29-4.8 Neighborhood Protection Standards

Columbia Development Code Public Hearing Draft 29-4.8:

Neighborhood Protection Photos, Janet Hammen

Illustrations of structures that meet 35' eave measurement (Section 29-4.8(h) of UDC)

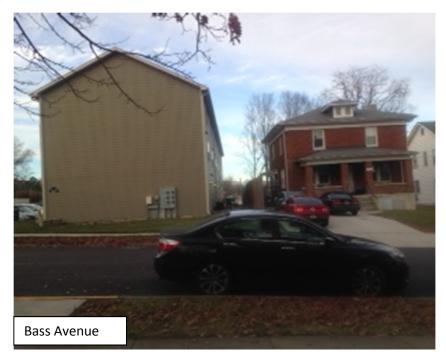
Accompanies J. Hammen's proposed changes submitted 12/8/16 to same section of UDC
